## **ADDENDUM No. 4**

### **Montello Street at Route 58 Re-alignment Project Carver, Massachusetts**

**August 17, 2021**

The following Addendum No. 4 is hereby issued to the Bid Documents entitled, “Montello Street at Route 58 Re-alignment,” dated July 21, 2021.

## CARVER MONTELLO STREET CONSTRUCTION DETAILS SHEET 43 OF 61

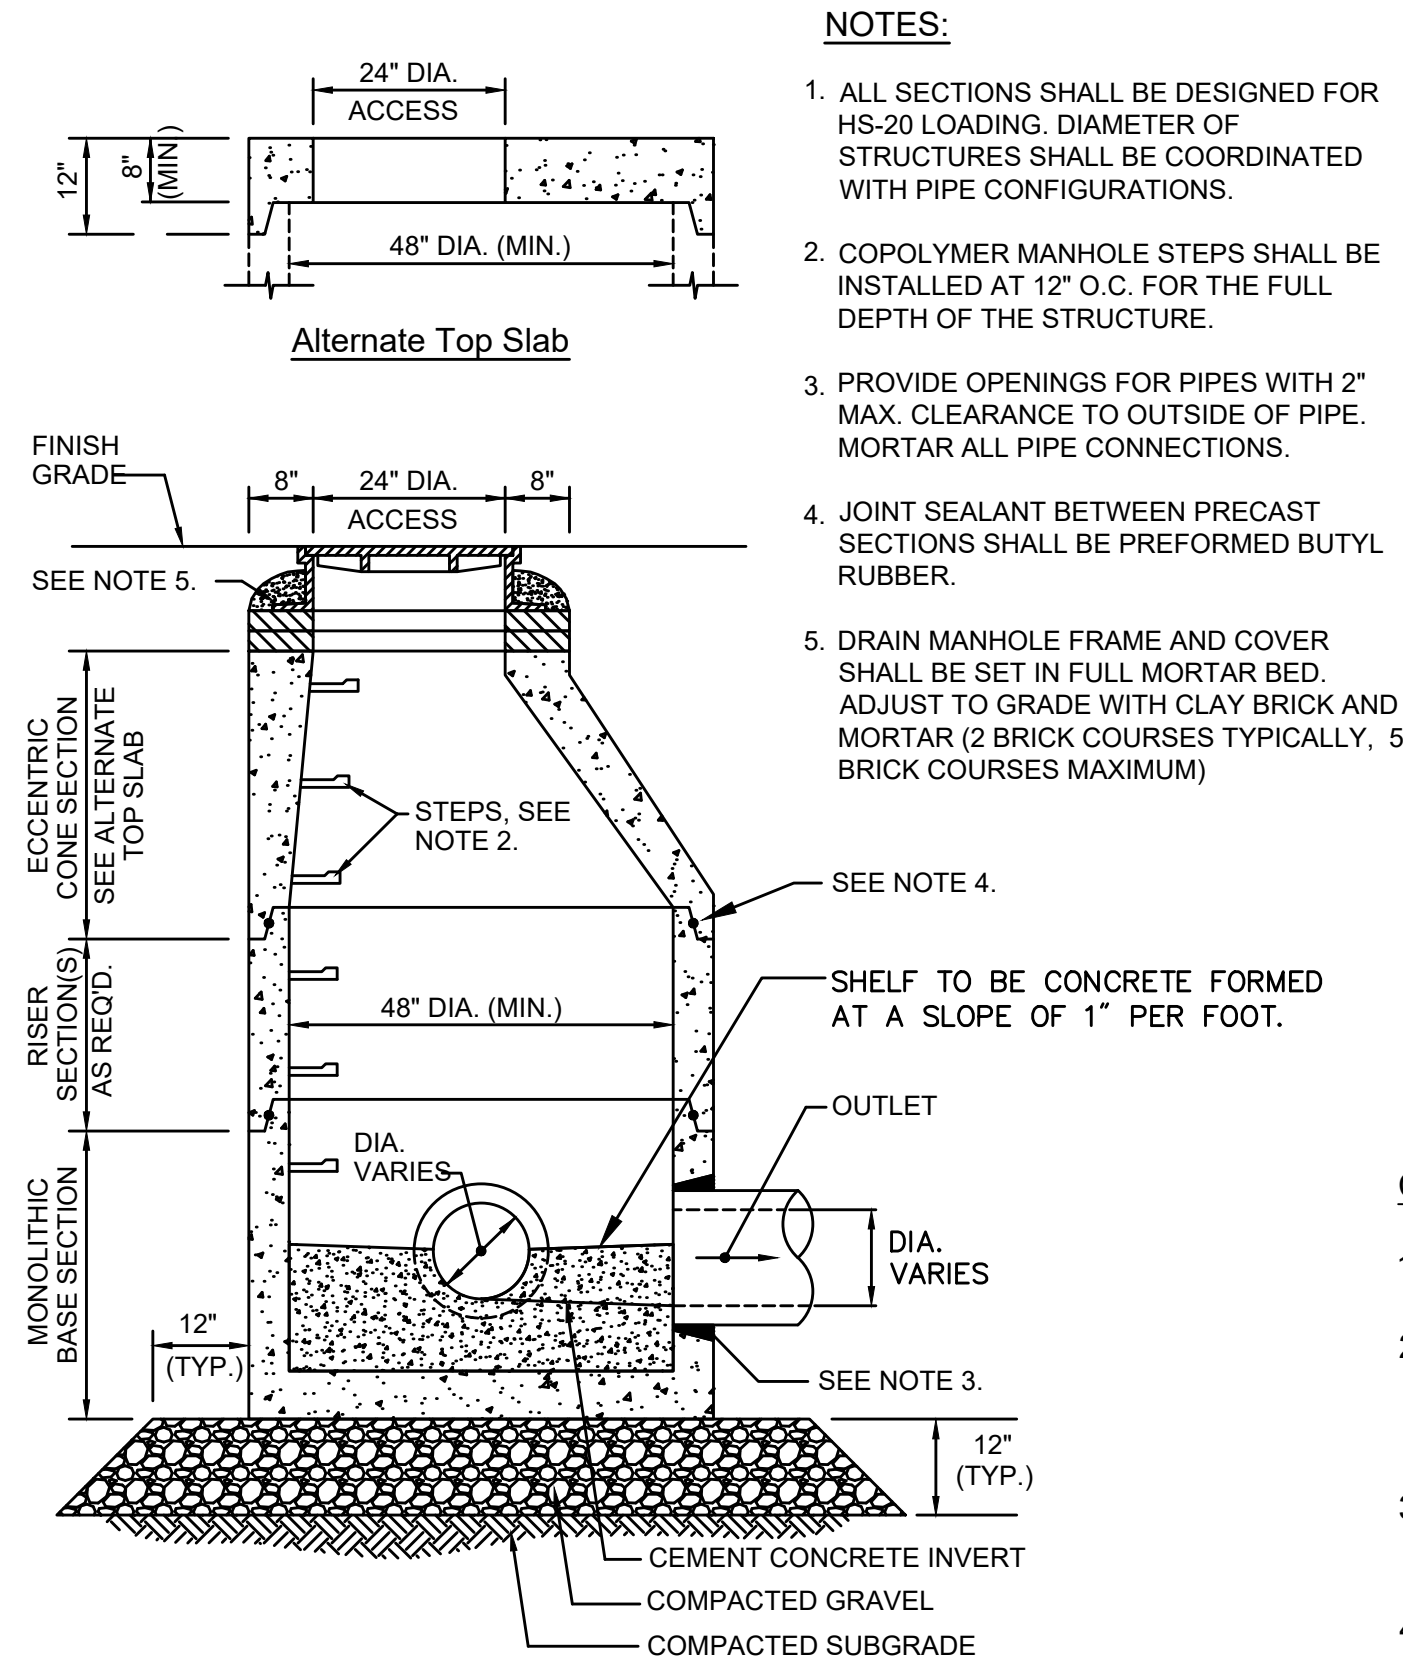
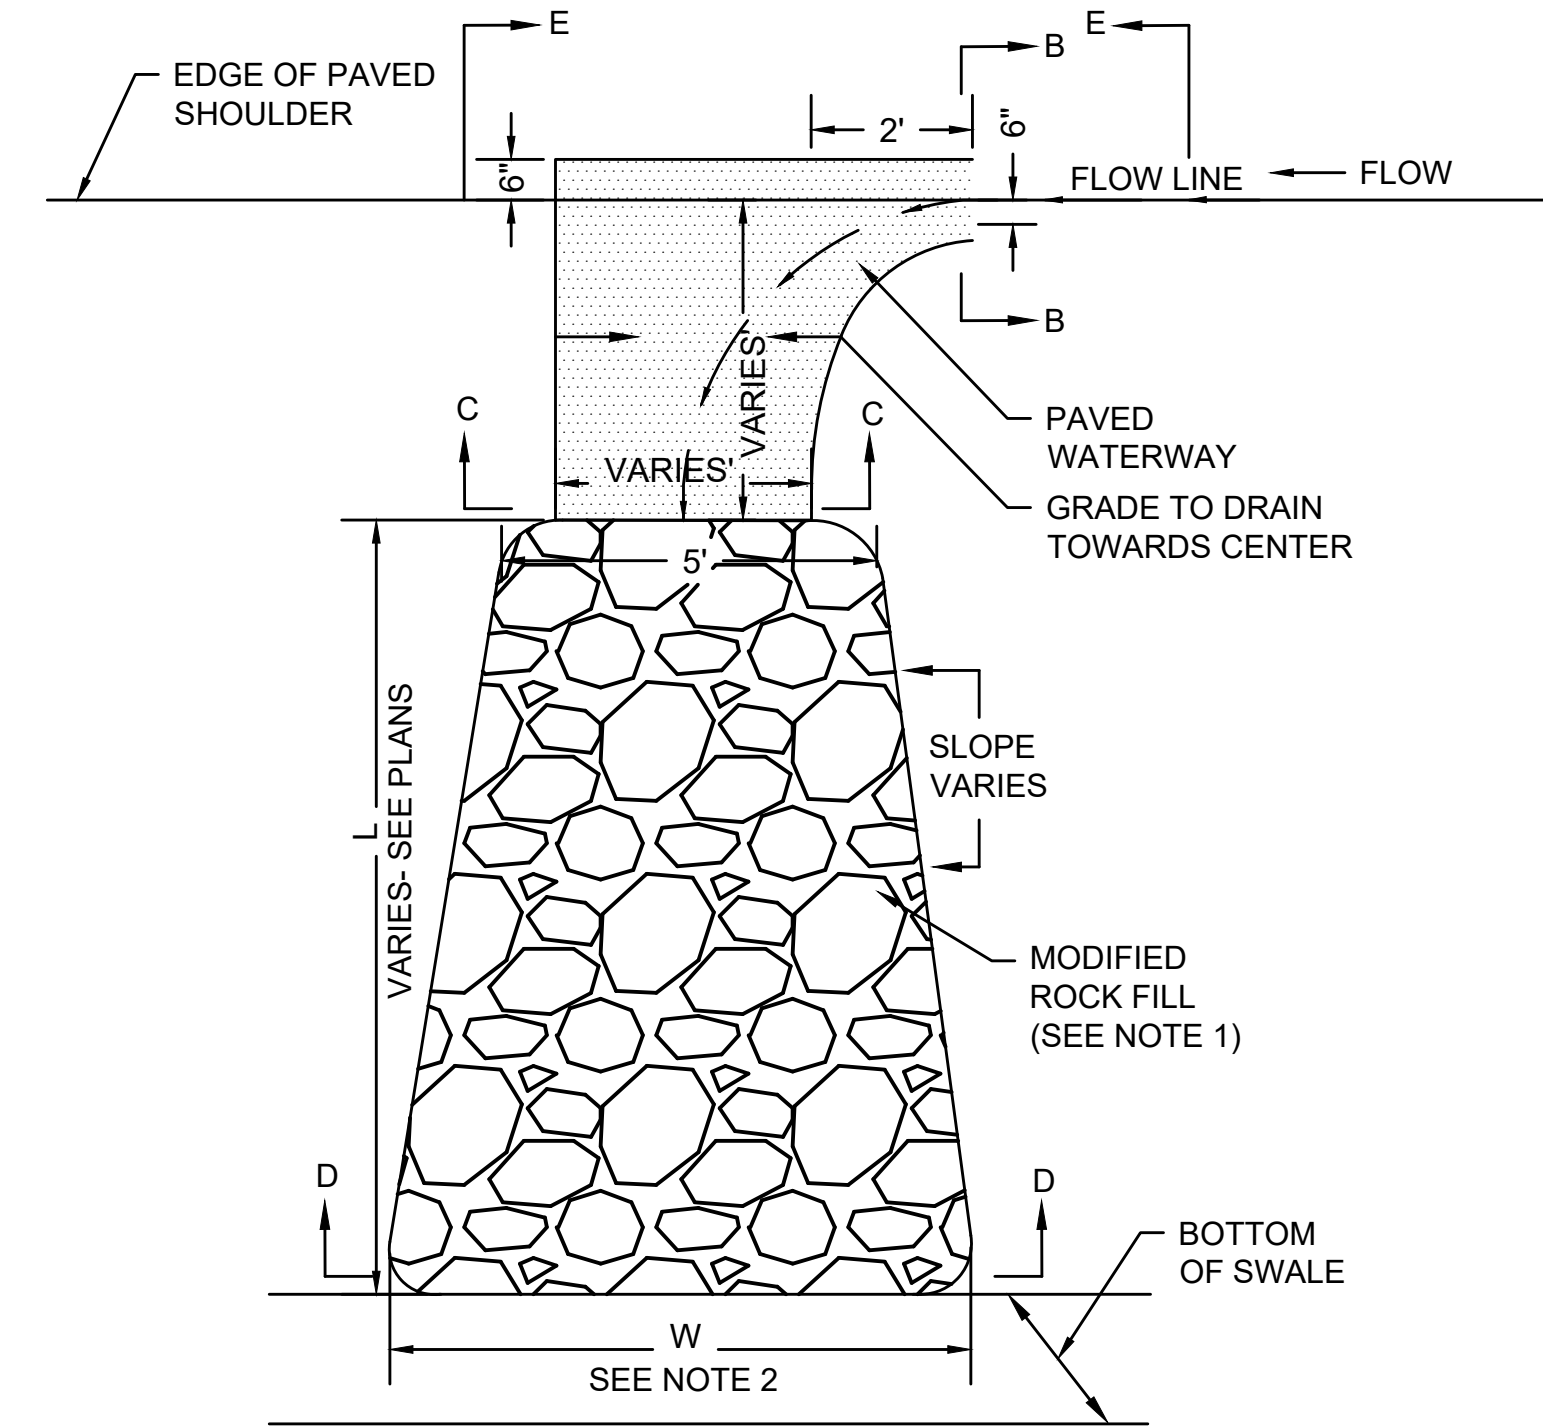
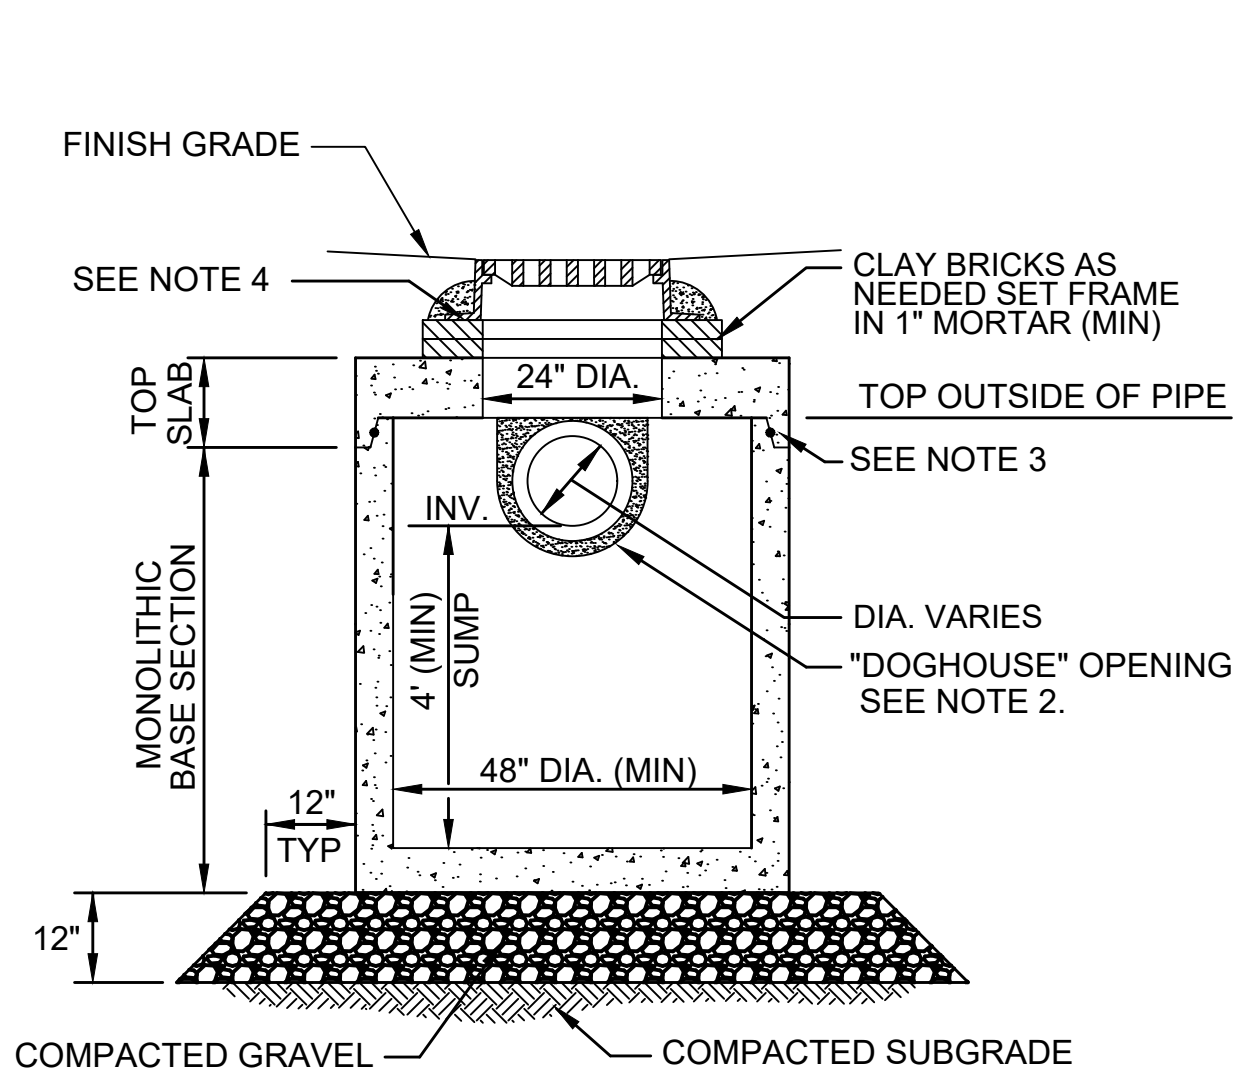
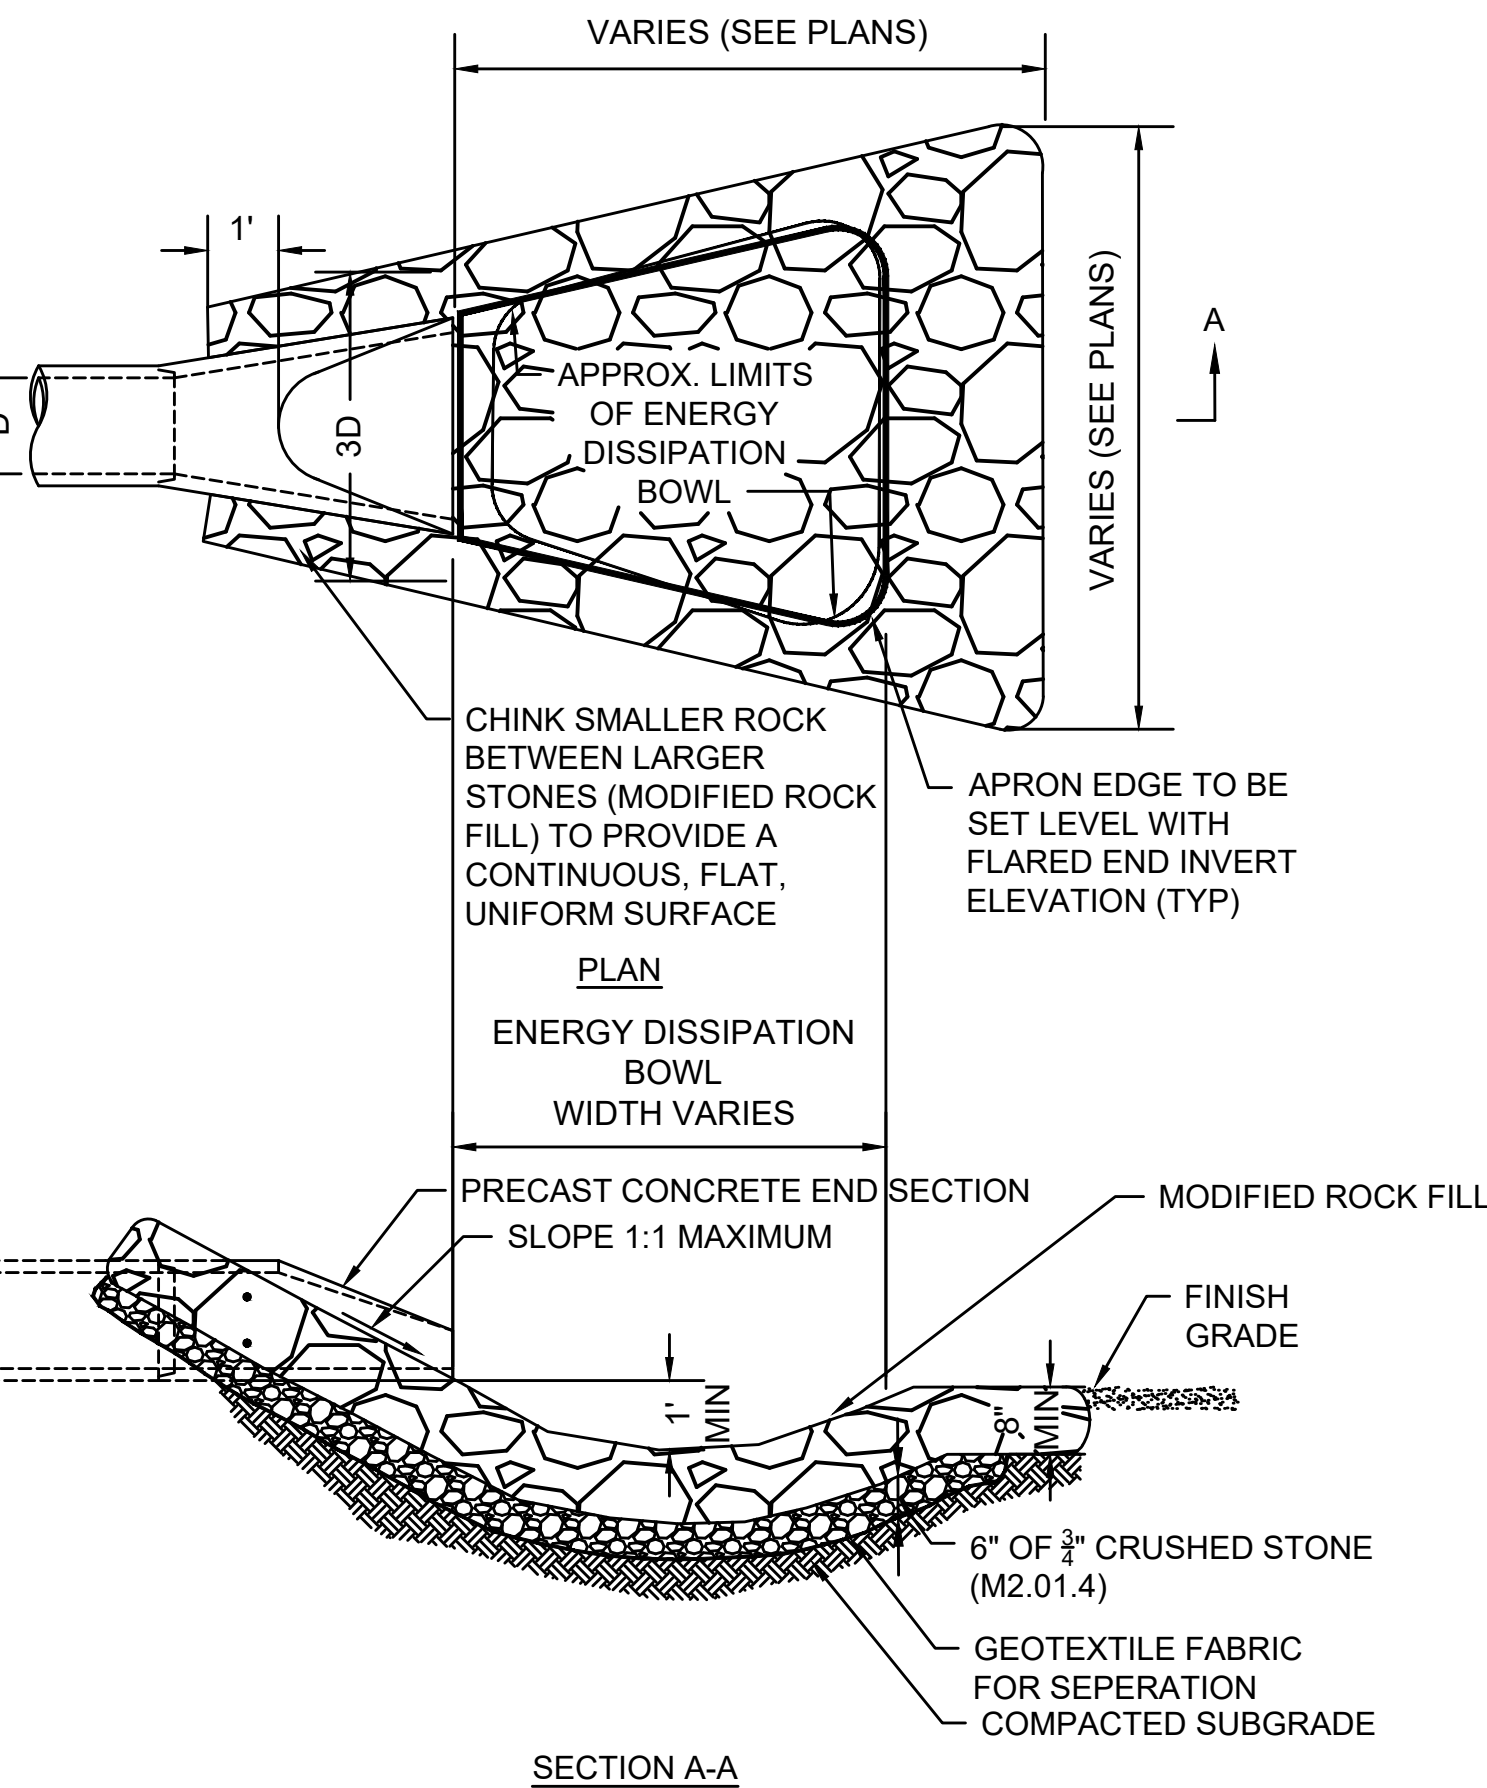
Q: The subdrain riser detail is showing ductile iron pipe and tee but the plans are showing PVC (solid and perforated) for this work. Please confirm the detail is wrong.

A: The detail shown in the plans is incorrect. **Bidders shall replace sheet 43 in the plans with the revised sheet 43, attached.**
